Access Compliance Report

Public Rights-of-Way

(Curb Ramps)

Intersection ID: 46814	Main Street: OLDE_IVY_WY	Cross Street: RED_BIRCH_DR	Location: S
ADA ID: 2BDFF133E91C	Ramp Type: PerpDiag	Initial Pass/Fail: Fail	Overall Compliance: No
Severity Score: 22.5			
Codes/Mitigation Info/Possible Solution		Field Measurements/Component Compliance

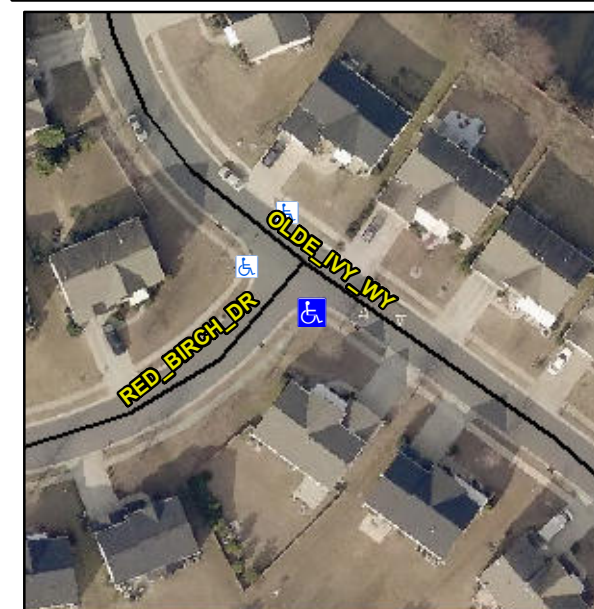
R304.5.1, R304.2.2, R304.5.3

Compliance	Description	Data	Compliance	Description	Data
N/A	Ramp Length (in)	46.0	No	Ramp Slope (%)	9.1
No	Ramp Width (in)	39.0	No	Ramp XSlope (%)	3.1
N/A	Flare Type LT	N/A	N/A	Flare Type RT	N/A
N/A	Flare Slope LT (%)	N/A	N/A	Flare Slope RT (%)	N/A
N/A	Flare Traversable LT?	N/A	N/A	Flare Traversable RT?	N/A
N/A	Landing Length (in)	N/A	N/A	DWS Provided?	N/A
N/A	Landing Width (in)	N/A	N/A	DWS Contrast?	N/A
N/A	Landing Slope (%)	N/A	N/A	DWS Length (in)	N/A
N/A	Landing X Slope (%)	N/A	N/A	DWS Full Width?	N/A
N/A	Landing Curb? (Y/N)	N/A	N/A	DWS Offset (in)	N/A
N/A	Shared Landing?	N/A			
N/A	Gutter Ponding?	N/A	N/A	Gutter Slope (%)	N/A
N/A	Gutter Lip Ht (in)	N/A	N/A	Gutter X Slope (%)	N/A
N/A	Painted X Walk1?	No	N/A	Painted X Walk2?	No
	X Walk 1 Direction	To NW		X Walk 2 Direction	To NE
N/A	X Walk 1 Width (in)	N/A	N/A	X Walk 2 Width (in)	N/A
	X Walk 1 Slope (%)	2.1		X Walk 2 Slope (%)	4.3
	X Walk 1 X Slope (%)	3.9		X Walk 2 X Slope (%)	0.4

Remove & Replace Curb Ramp With Two New Directional Ramps or Equivalent.
